Access Compliance Report Public Rights-of-Way (Island Curb Cuts)

Intersection ID: N/AMain Street: S CALDWELL STCross Street: E STONEWALL STLocation: WADA ID: 599B02F907A4Curb Cut Type: MedianRefuge2Initial Pass/Fail: Fail Overall Compliance: NoSeverity Score: 0

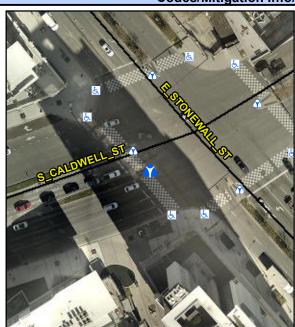
Painted X Walk1?	Yes N	l/A	DWS 1 Provided?	N/A
N/A	V Malle 4 Dinastian				
	X Walk 1 Direction	To SE N	l/A	DWS 1 Contrast?	N/A
N/A	X Walk 1 Width (In)	144.0 N	l/A	DWS 1 Length (In)	N/A
N/A	Road 1 Slope (%)	3.7 N	l/A	DWS 1 Full Width?	N/A
N/A	Road 1 X Slope (%)	2.1 N	l/A	DWS 1 Offset (In)	N/A
No	Refuge 2 Length (In)	34.5 N	l/A	Gutter 2 Ponding?	N/A
Yes	Refuge 2 Width (In)	165.0 N	l/A	Gutter 2 Lip Ht (In)	N/A
Yes	Refuge 2 Slope (%)	1.2 N	l/A	Gutter 2 Slope (%)	N/A
Yes	Refuge 2 X Slope (%)	1.7 N	l/A	Gutter 2 X Slope (%)	N/A
N/A	Painted X Walk2?	Yes N	l/A	DWS 2 Provided?	N/A
N/A	X Walk 2 Direction	To NW N	l/A	DWS 2 Contrast?	N/A
N/A	X Walk 2 Width (In)	144.0 N	l/A	DWS 2 Length (In)	N/A
N/A	Road 2 Slope (%)	2.8 N	l/A	DWS 2 Full Width?	N/A
N/A	Road 2 X Slope (%)	1.6 N	l/A	DWS 2 Offset (In)	N/A
N/A	Refuge 3 Length (in)	N/A N	l/A	Gutter 3 Ponding?	N/A
N/A	Refuge 3 Width (in)	N/A N	l/A	Gutter 3 Lip Ht (in)	N/A
N/A	Refuge 3 Slope (%)	N/A N	I/A	Gutter 3 Slope (%)	N/A

Remove & Replace Entire Refuge.
